PLATTE SELF STORAGE WATER & UTILITY SERVICE PLAN COVER SHEET MAY 2024

PLATTE SELF STORAGE

GRADING AND EROSION CONTROL PLAN

WATER & UTILITY SERVICE PLAN
COVER SHEET

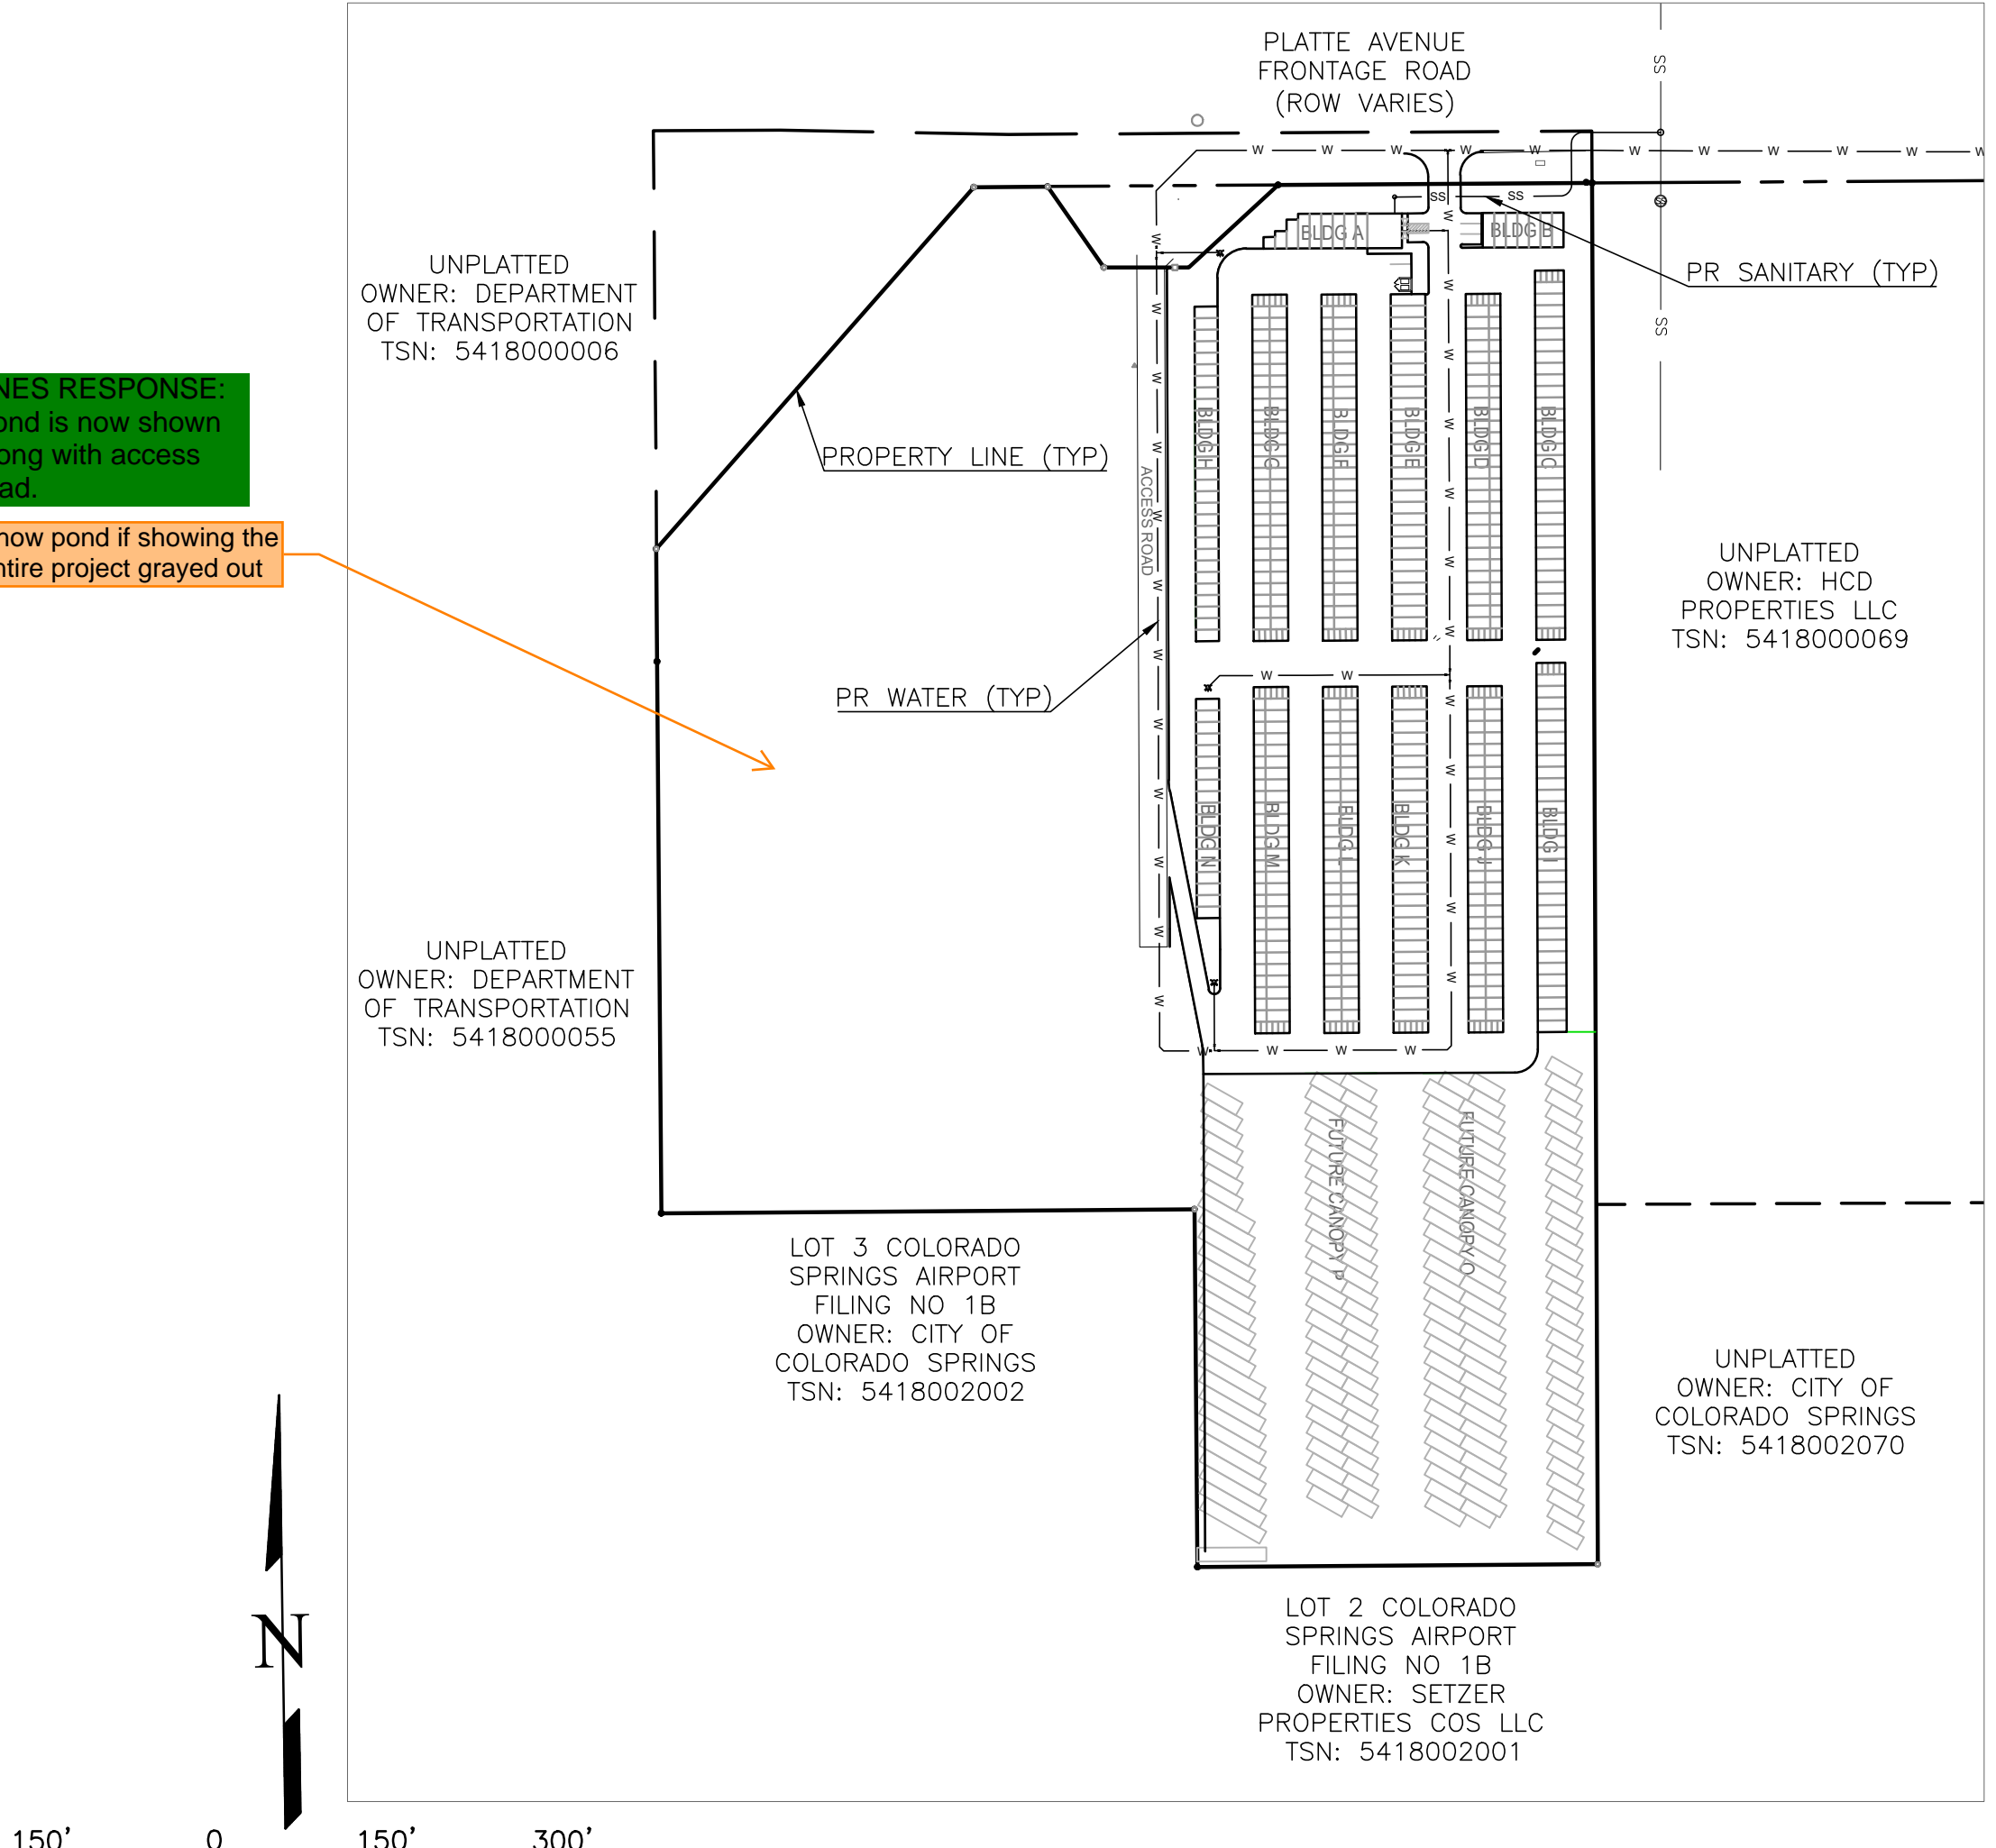
Water and Sanitary plans and profiles are not reviewed within the GEC and Storm Water Construction Plan. Please removed sheet 1 to 6.

FINES RESPONSE
Pond is now shown along with access road.
Show pond if showing the entire project grayed out

FINES RESPONSE
Noted.

GRADING AND EROSION CONTROL PLAN
 OVERVIEW SHEET

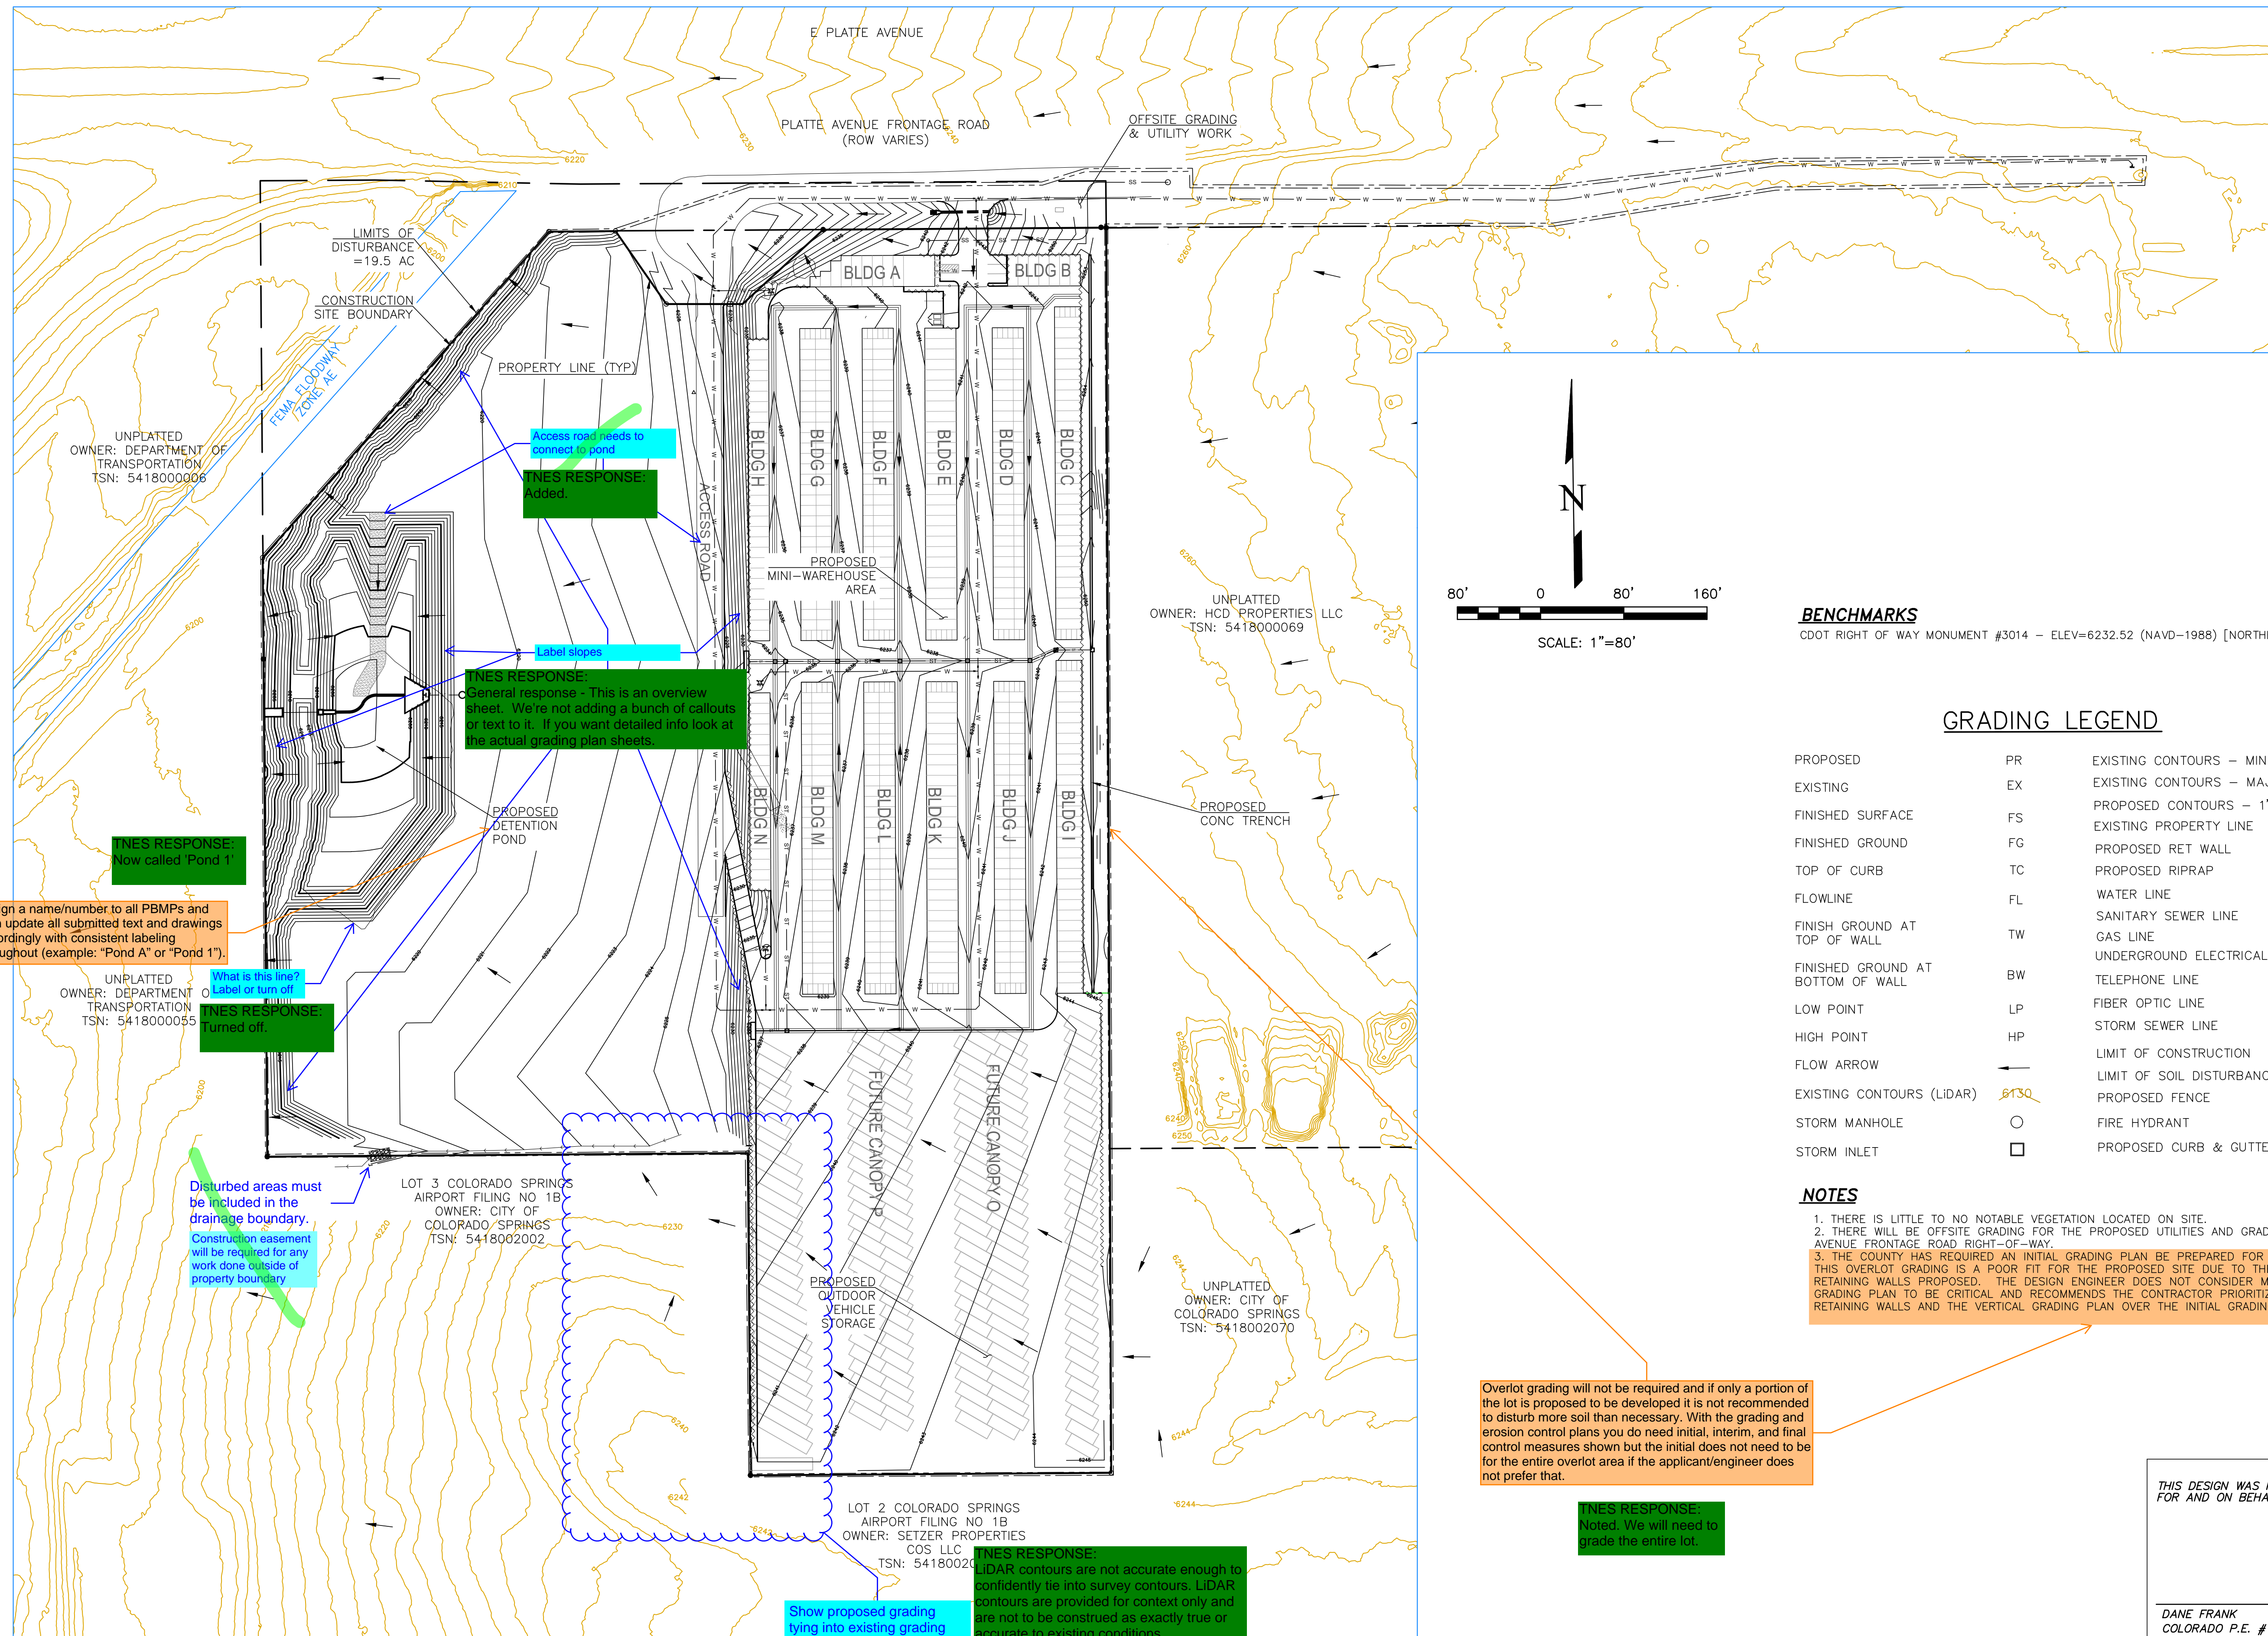
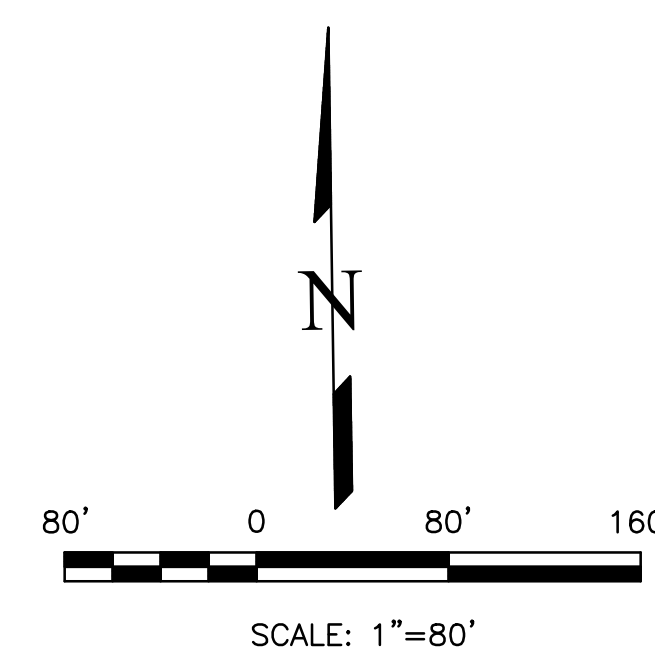
Overlot grading will not be required and if only a portion of the lot is proposed to be developed it is not recommended to disturb more soil than necessary. With the grading and erosion control plans you do need initial, interim, and final control measures shown but the initial does not need to be for the entire overlot area if the applicant/engineer does not prefer that.

Assign a name/number to all PBMPs and then update all submitted text and drawings accordingly with consistent labeling throughout (example: "Pond A" or "Pond 1").

What is this line? Label or turn-off?

Disturbed areas must be included in the drainage boundary. Construction easement will be required for any work done outside of property boundary.

General response - This is an overview sheet. We're not adding a bunch of callouts or text to it. If you want detailed info look at the actual grading plan sheets.

LIDAR contours are not accurate enough to confidently tie into survey contours. LIDAR contours are provided for context only and are not to be construed as exactly true or accurate to existing conditions. Also, look at the actual grading plan sheets, since this is just an overview sheet.

Noted. We will need to grade the entire lot.
